Access Compliance Report

Public Rights-of-Way

(Curb Ramps)

Intersection ID: 16545	Main Street: N_SHARON_AMITY_RD	Cross Street: MONROE_RD	Location: NW
ADA ID: 3A2A23120E9F	Ramp Type: Perp	Initial Pass/Fail: Fail	Overall Compliance: No
Severity Score: 8.75			
Codes/Mitigation Info/Possible Solution		Field Measurements/Component Compliance

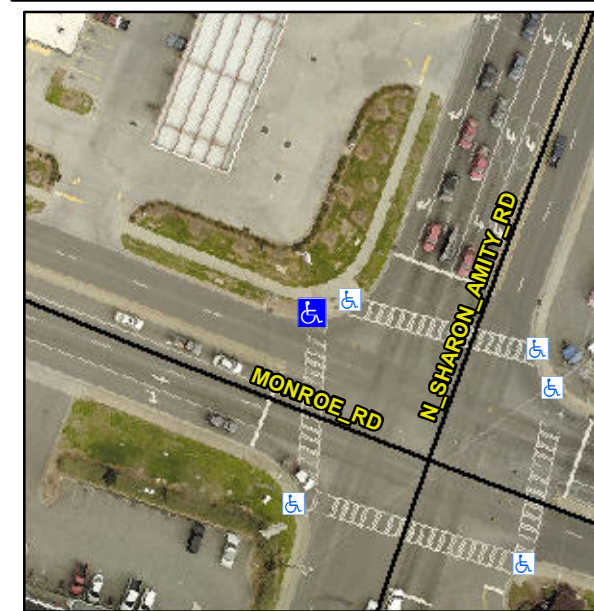
Not Found, R304.5.1

Compliance	Description	Data	Compliance	Description	Data
N/A	Ramp Length (in)	60.0	Yes	Ramp Slope (%)	5.2
No	Ramp Width (in)	42.0	Yes	Ramp XSlope (%)	0.2
N/A	Flare Type LT	N/A	N/A	Flare Type RT	N/A
N/A	Flare Slope LT (%)	N/A	N/A	Flare Slope RT (%)	N/A
N/A	Flare Traversable LT?	N/A	N/A	Flare Traversable RT?	N/A
N/A	Landing Length (in)	N/A	N/A	DWS Provided?	N/A
N/A	Landing Width (in)	N/A	N/A	DWS Contrast?	N/A
N/A	Landing Slope (%)	N/A	N/A	DWS Length (in)	N/A
N/A	Landing X Slope (%)	N/A	N/A	DWS Full Width?	N/A
N/A	Landing Curb? (Y/N)	N/A	N/A	DWS Offset (in)	N/A
N/A	Shared Landing?	N/A			
N/A	Gutter Ponding?	N/A	N/A	Gutter Slope (%)	N/A
N/A	Gutter Lip Ht (in)	N/A	N/A	Gutter X Slope (%)	N/A
N/A	Painted X Walk1?	Yes	N/A	Painted X Walk2?	N/A
	X Walk 1 Direction	To SW		X Walk 2 Direction	N/A
N/A	X Walk 1 Width (in)	101.0	N/A	X Walk 2 Width (in)	N/A
	X Walk 1 Slope (%)	2.6		X Walk 2 Slope (%)	N/A
	X Walk 1 X Slope (%)	2.0		X Walk 2 X Slope (%)	N/A

Remove & Replace Entire Ramp.
